SUPPLEMENTAL BID BULLETIN NO. 1
21 November 2023

Design, Supply, Delivery, Installation, Supervision, Integration, Training, Testing, and Commissioning of Lighting Facilities for the Multi-Purpose Studio for the Visayas Media Hub (Procurement/Contract No. 2023-PCO-075)

NEWS STUDIO 1 LIGHTING DESIGN

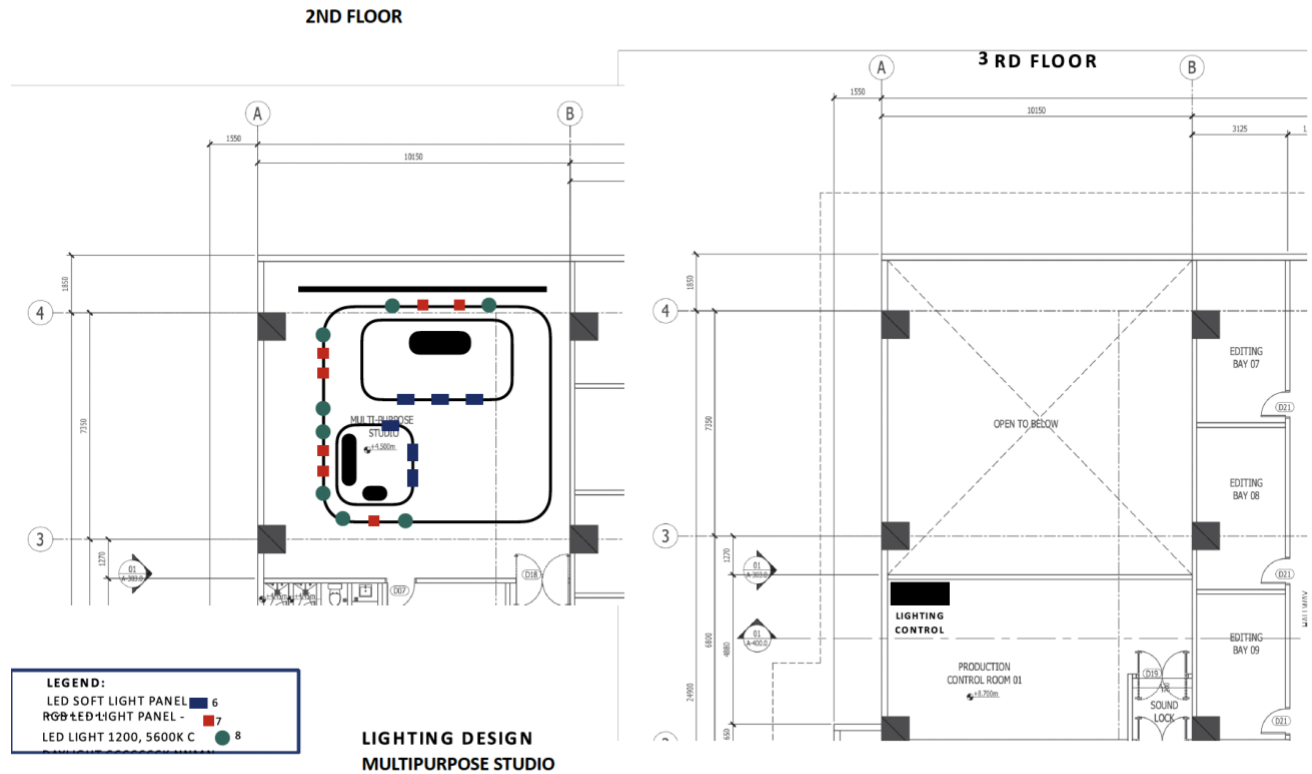
7. Item No. 16.0 Clarification on the dimension (LxWxH) of cyclorama cloth required?	equipment. There should also be an allowance for future expansion. 7. Green: (LxH) = 6m x 6m; White: 6m x 6m; Black: 12m x 6m The Cyclorama clothes are retractable (on rails).
Clarification of the multi-purpose studio design	Please see attached layout for your reference
